RFP Title: Removal and Disposal of Residuals from the South Sedimentation Basin (Exp. 12/31/25)

ADDENDUM NO. 6

**REMOVAL AND DISPOSAL OF RESIDUALS FROM THE
SOUTH SEDIMENTATION BASIN
PHILIP J. HOLTON PURIFICATION PLANT,
61 NORTH ROAD, SCITUATE, RI**

I/R	DATE	DESCRIPTION
1	07/18/2023	Addendum No. 6

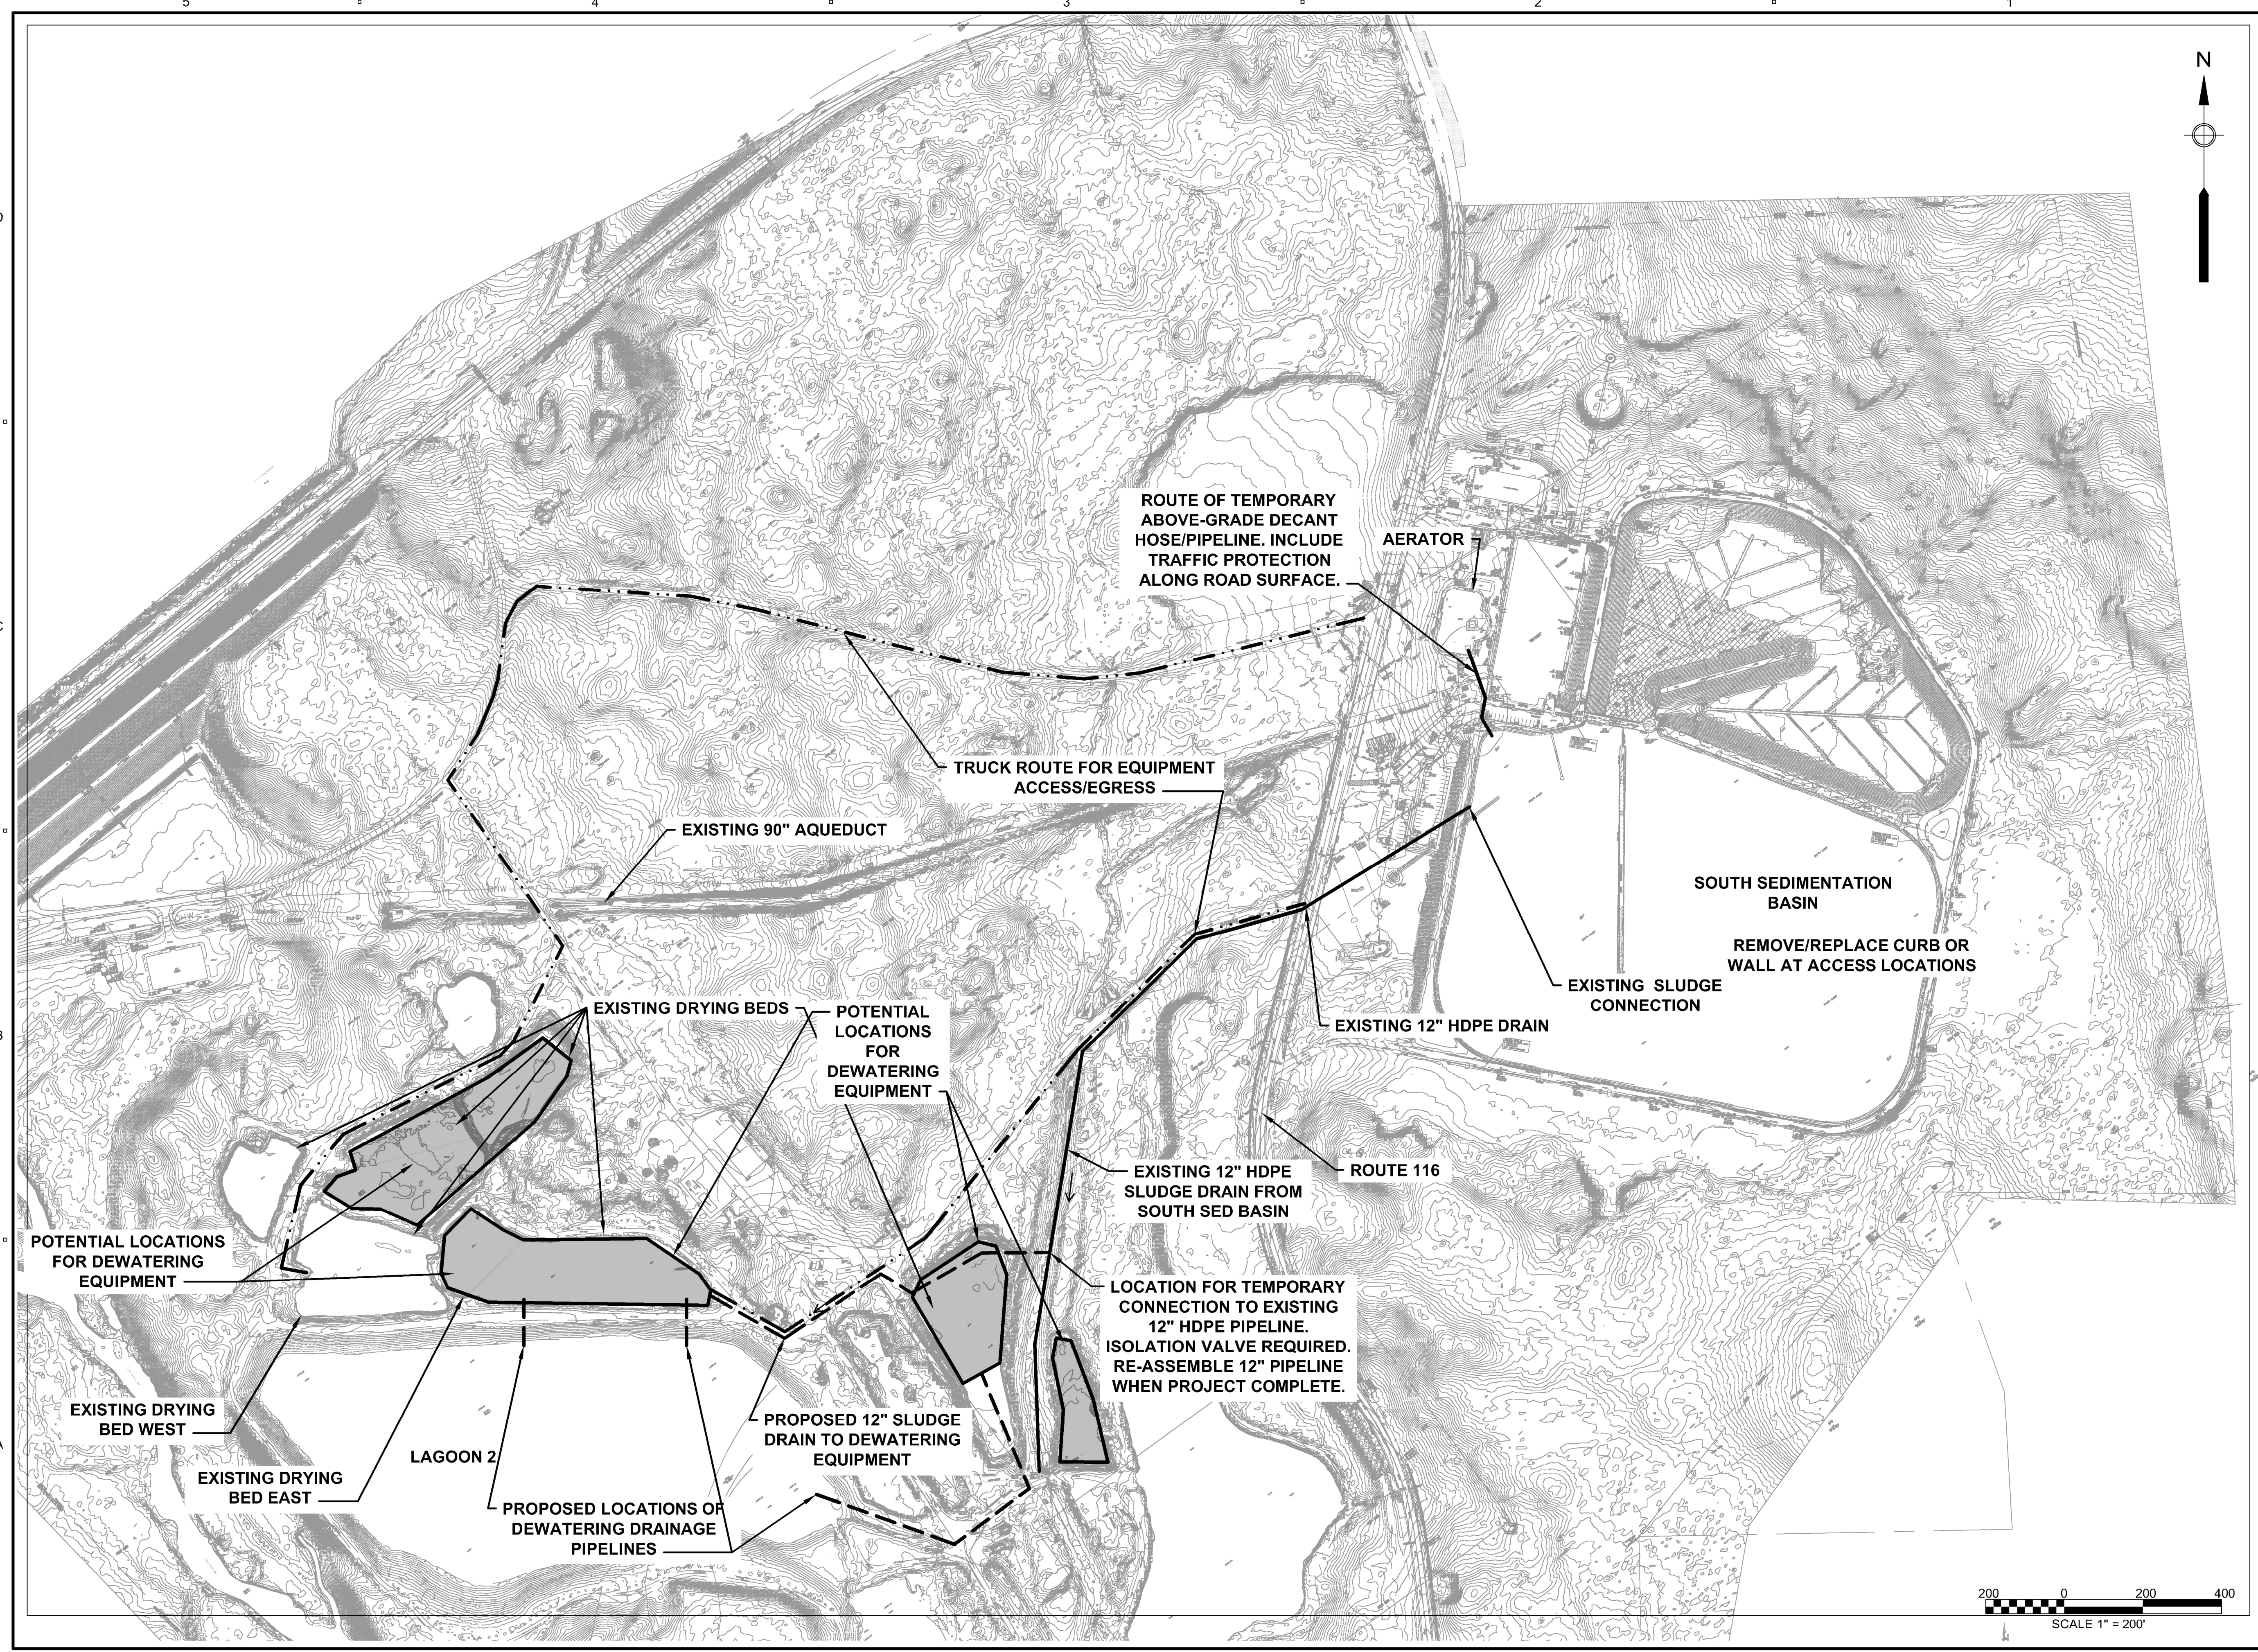
Delete Appendix D Site Plan and replace it with the updated Site Plan included with this addendum.
